ADDITIONAL INFORMATION REQUIRED FOR ENVIRONMENTAL
IMPACT ASSESSMENT IN CONNECTION WITH 40 CFR 190

DOCKET NO.: 40-8027

FACILITY: Sequoyah Uranium Hexafluoride Production Plant

SUBJECT: SAFETY EVALUATION REPORT - LICENSE AMENDMENT
APPLICATION FOR AUTHORIZATION TO REMODEL RAFFINATE
STORAGE POND NO. 1
LICENSE NO. SUB-1010
AMENDMENT NO. 6

Fig. 1. Raffinate Pond and Monitoring Stations

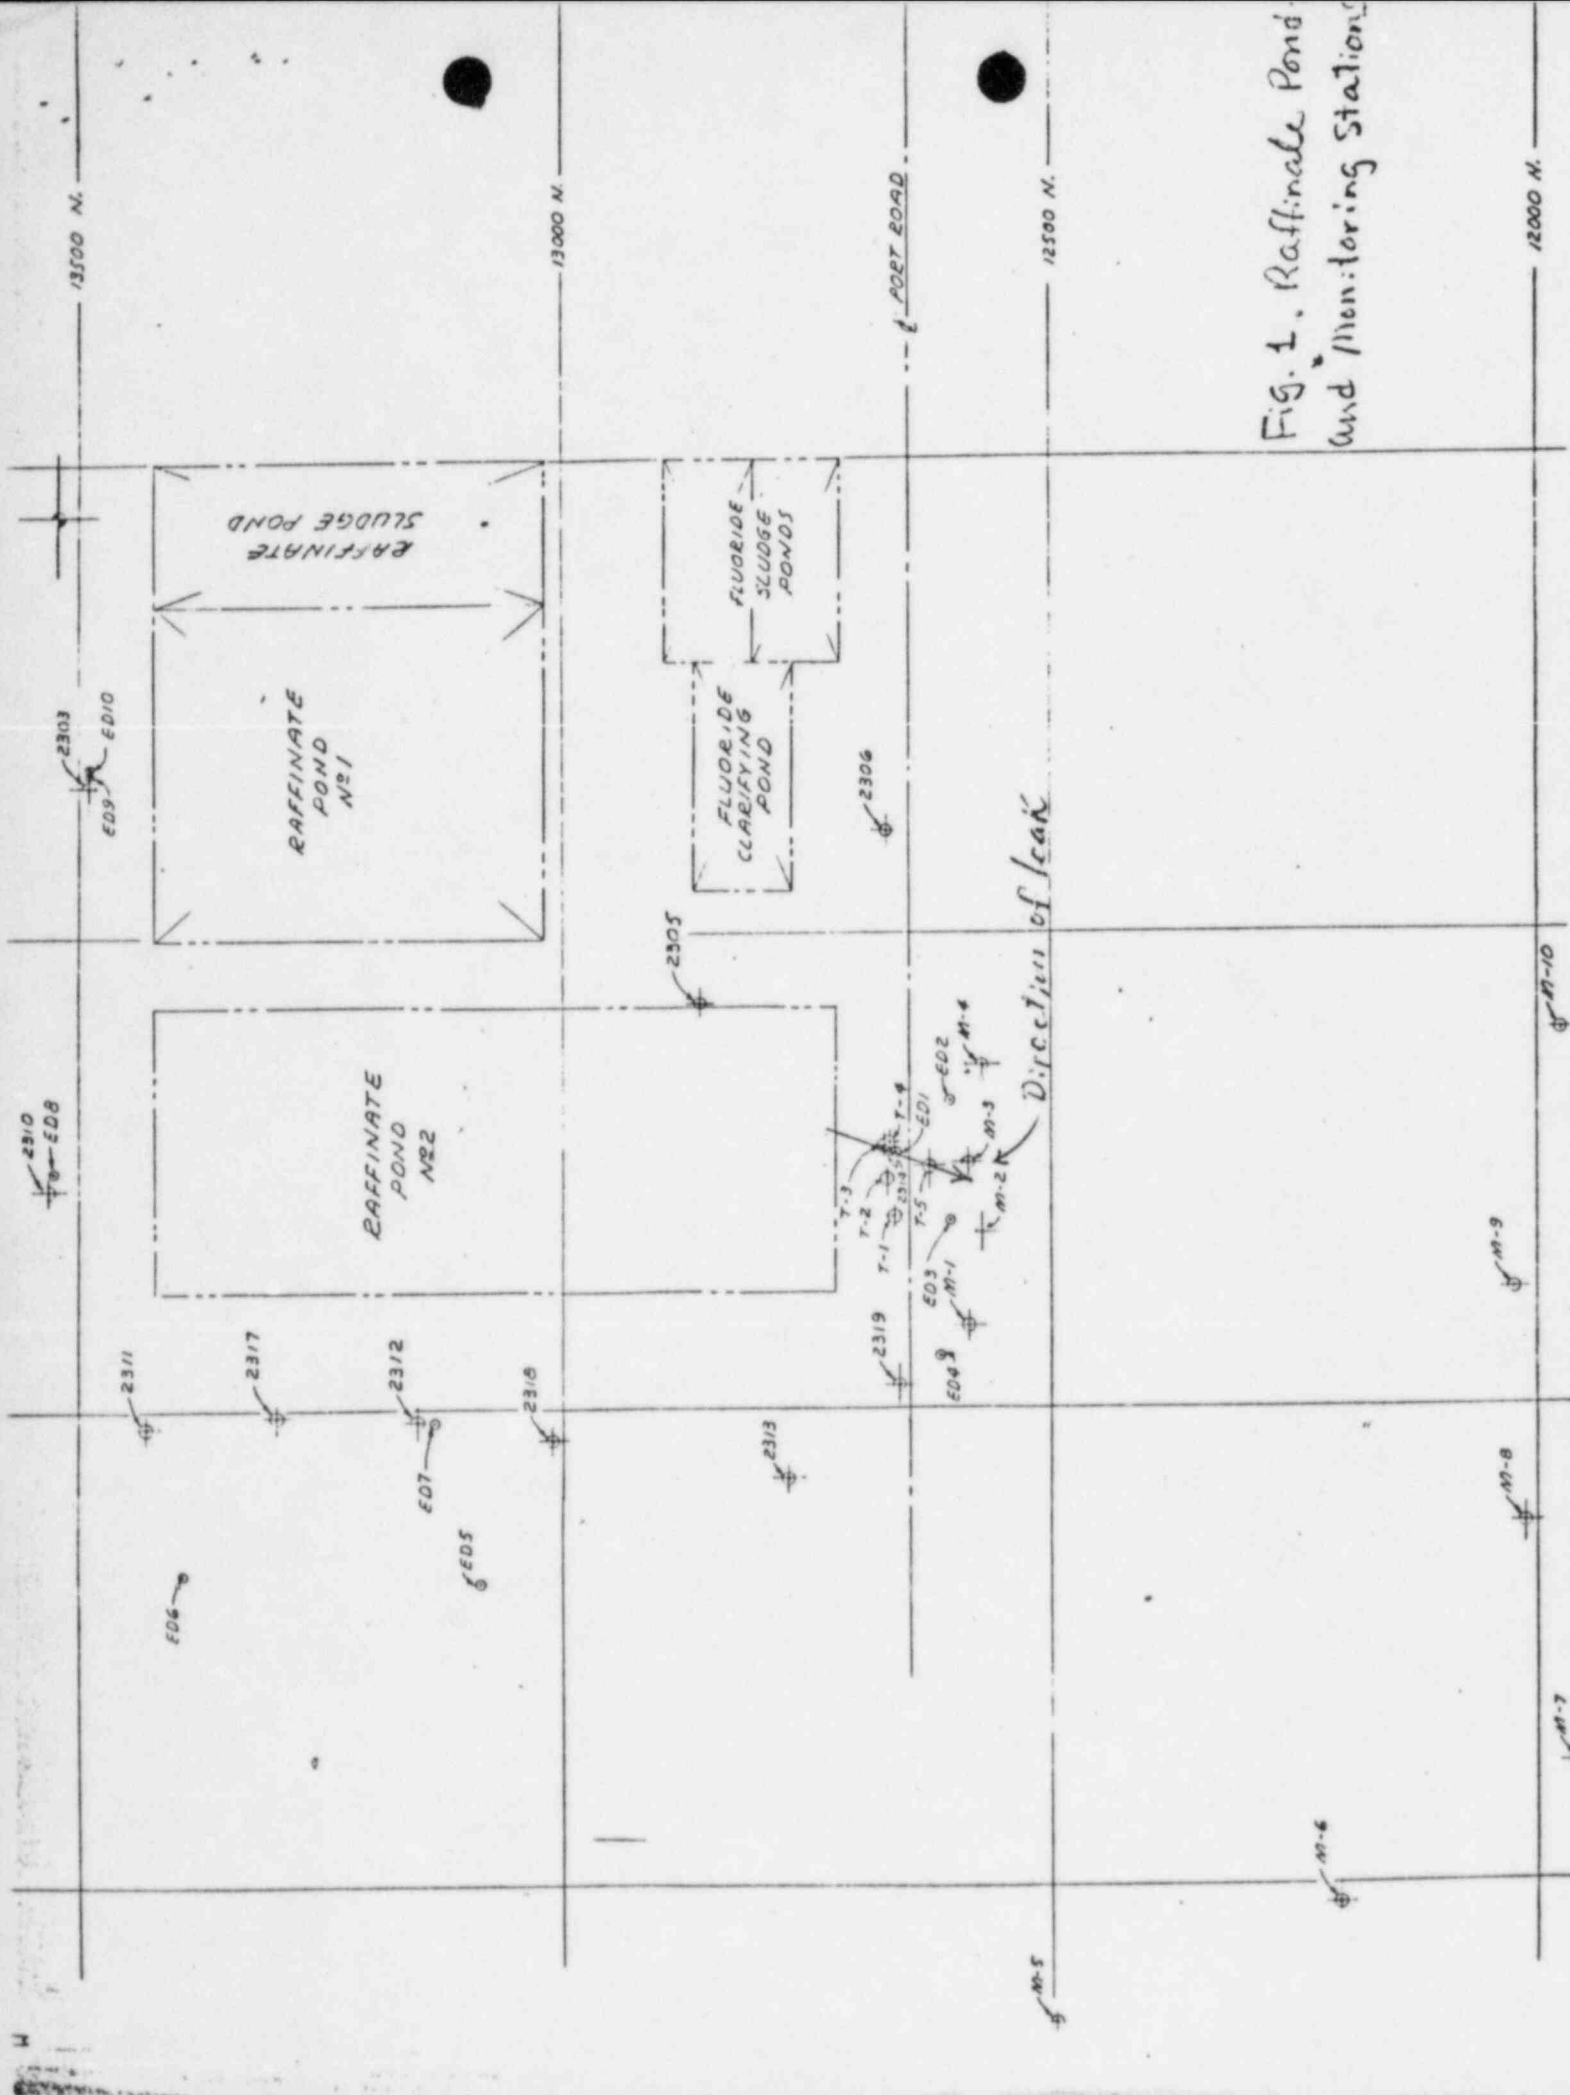
The M series groundwater monitoring wells (see Table 1 and Figure 1) were installed in 1974 among others for monitoring the leak from raffinate storage pond #2. Since their installation, all monthly collected samples (except M-3 well which is not included in the application) have shown an insignificant level both in radiological and non-radiological contaminants. The result of the extensive studies regarding the leak of pond #2, however, may be summarized as follows (see KM's letter to NRC dated February 3, 1979, annual report concerning leakage of pond #2):

Based on the above conclusions, the staff considers that KM's request for quarterly sampling from the M series wells is adequate. Furthermore, in order to ensure an earlier warning of further spreading from the leakage, the staff proposed to the licensee that should an elevated nitrate level be detected in the M-6 to M-10 wells which are located about 800 feet south of the pond, KM shall investigate the possible cause of this nitrate elevation in the sample and report to the NRC.

1. If any groundwater sample from well M-5, M-6, M-7, M-8, M-9, or M-10 shows concentration in excess of 10 mg/liter of nitrate (as N), the licensee shall investigate the cause of the elevated analytical result and promptly report to the NRC Inspection and Enforcement Region IV Office.
